SUBJECT: City of Wilsonville Plan Amendment  
DLCD File Number 001-10

**AN ORDINANCE OF THE CITY OF WILSONVILLE AMENDING THE VILLEBOIS VILLAGE MASTER PLAN TO RELOCATE THE PLANNED ELEMENTARY SCHOOL FROM THE NORTH SPECIFIC AREA PLAN (SAP) TO THE EAST SPECIFIC AREA PLAN (SAP) WITH ASSOCIATED MAP AND TEXT MODIFICATIONS.**

Attachment 2: Planning Commission Recommended *Proposed Legislative  
Amendment Villebois Village Master Plan (case file no. LP10-0001)*

## PROPOSED LEGISLATIVE AMENDMENT VILLEBOIS VILLAGE MASTER PLAN (City File No. LP10-0001)

**Exhibit 7**  
**Figure 6A: Onsite Stormwater**  
**Facilities**

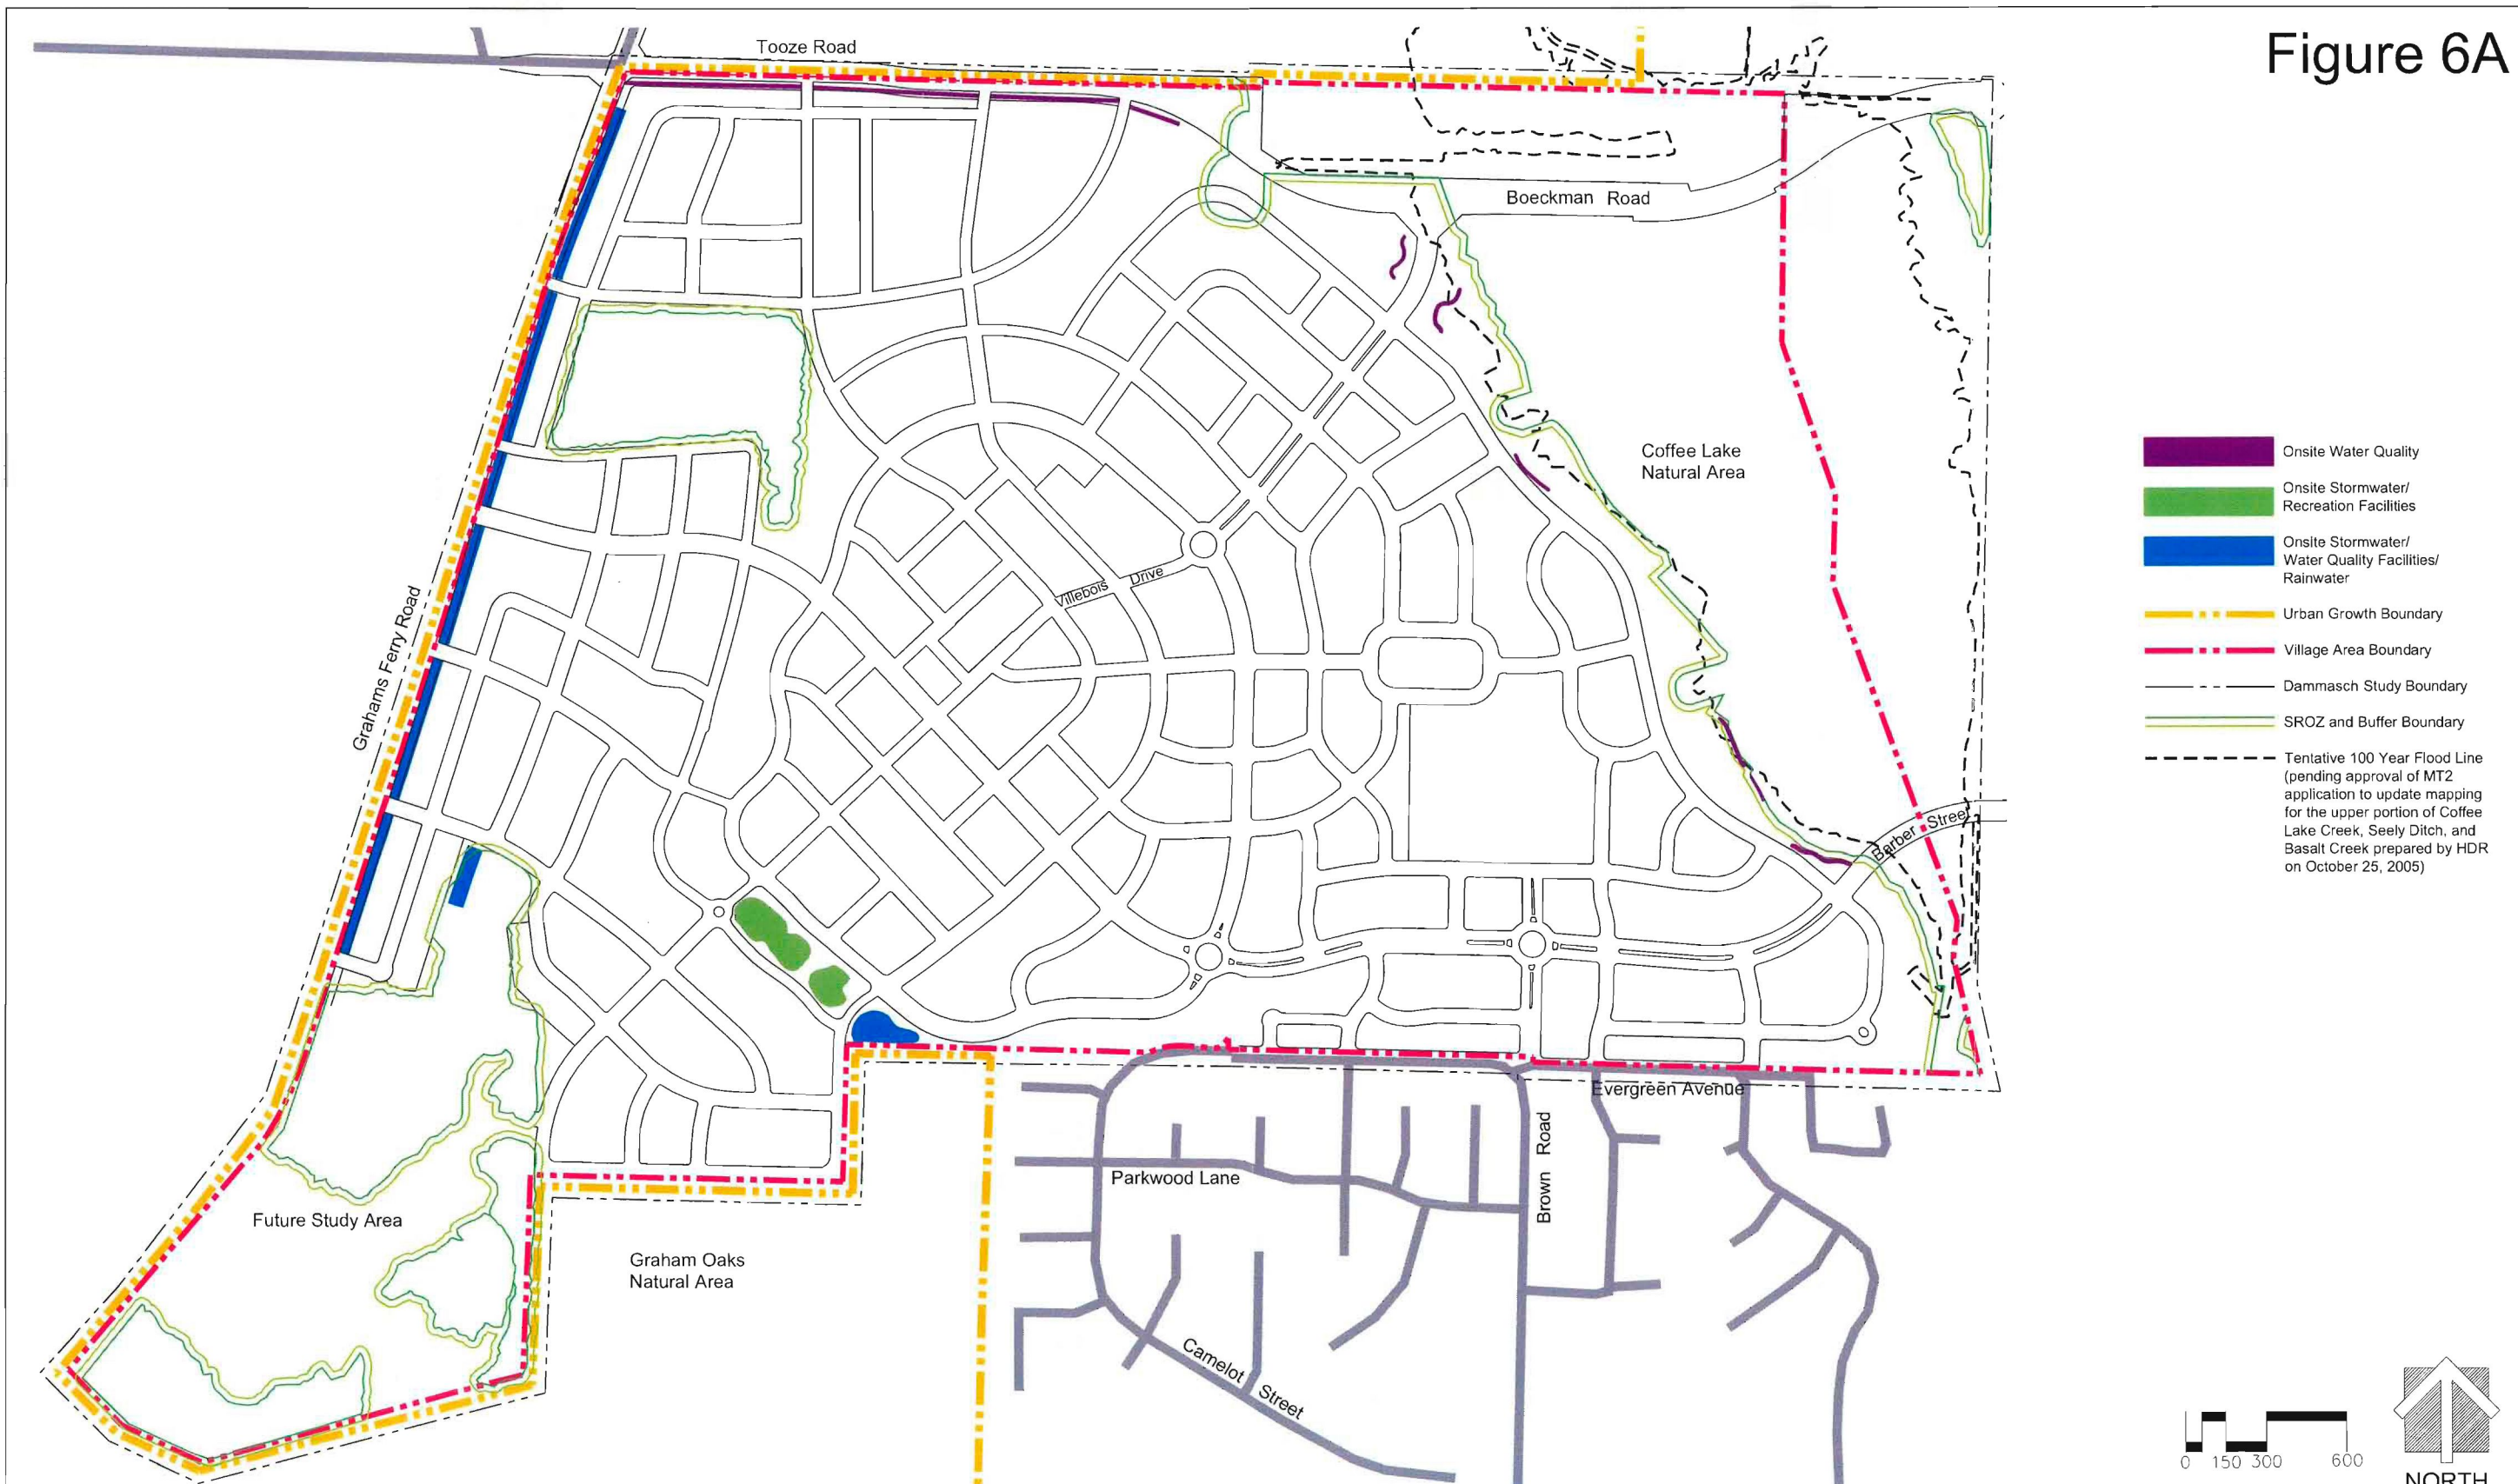
- **Figure 6A – Onsite Stormwater Facilities** has been modified to depict a new street grid reflecting the new school site in the east and the reprogramming of residential uses in the north. No other changes are proposed.

**Exhibit 8**  
**Figure 6B: Onsite Rainwater**  
**Management**

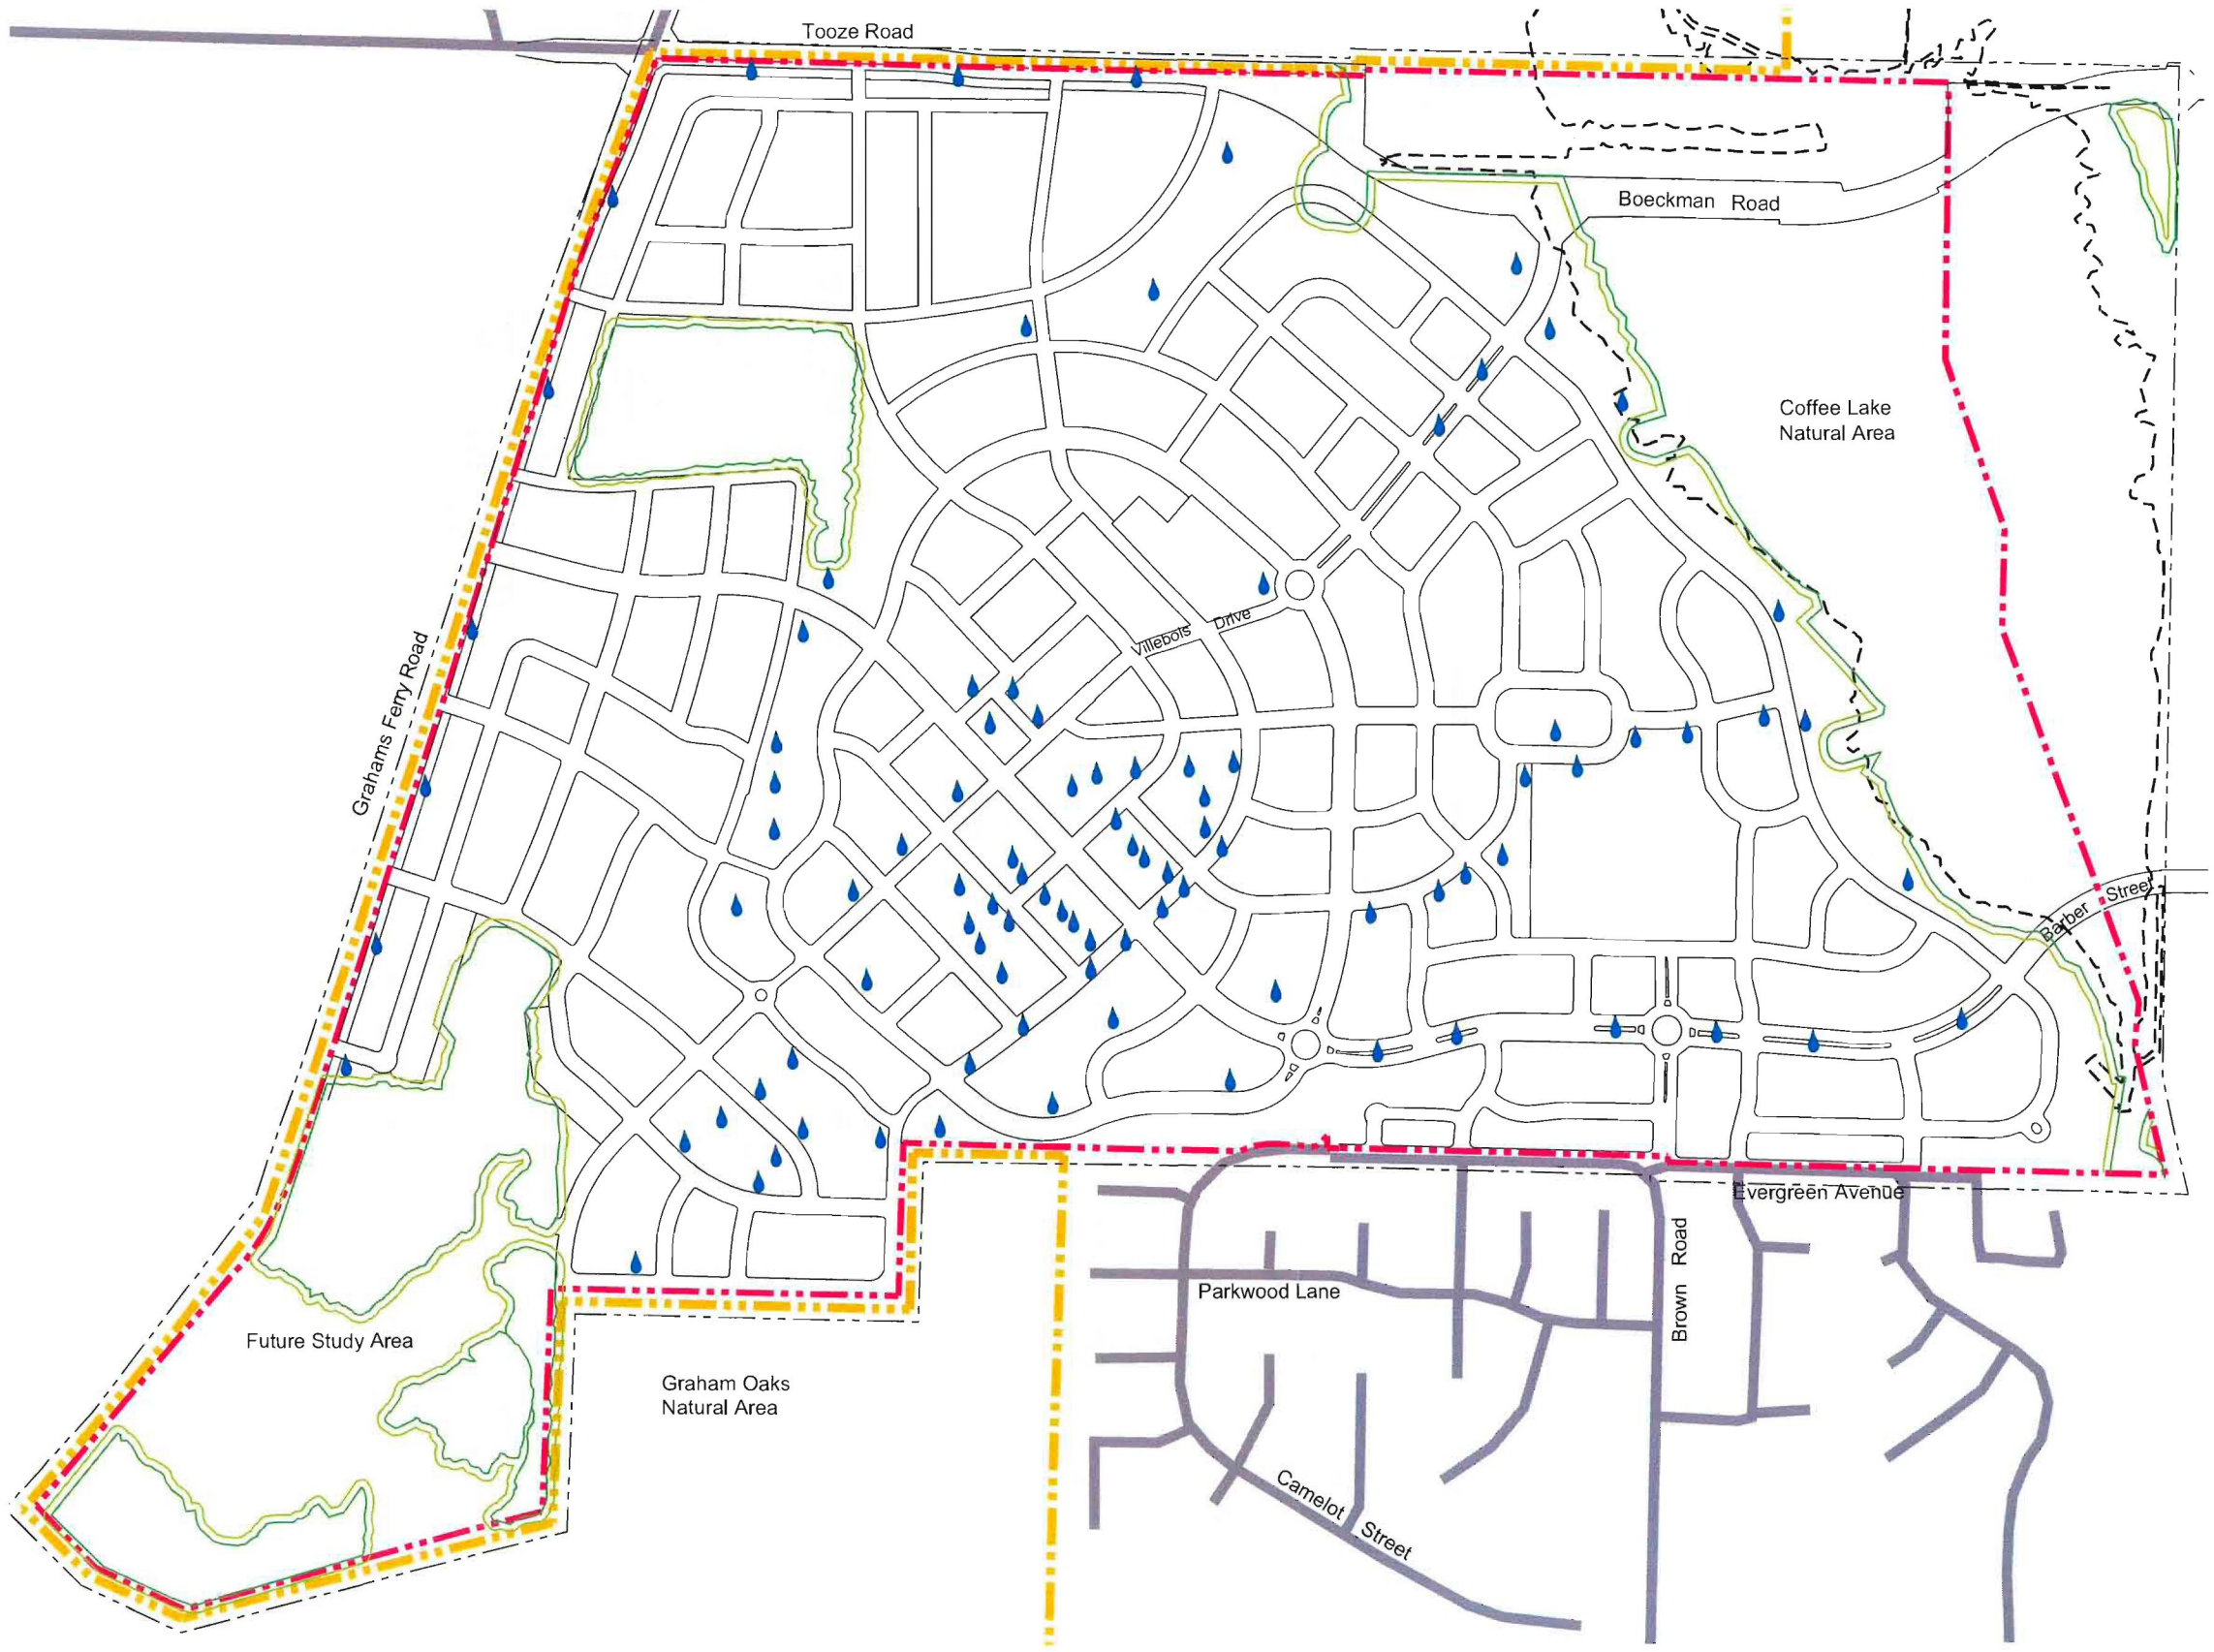
- **Figure 6B – Onsite Rainwater Management** has been modified to depict a new street grid reflecting the new school site in the east and the reprogramming of residential uses in the north. No other changes are proposed.
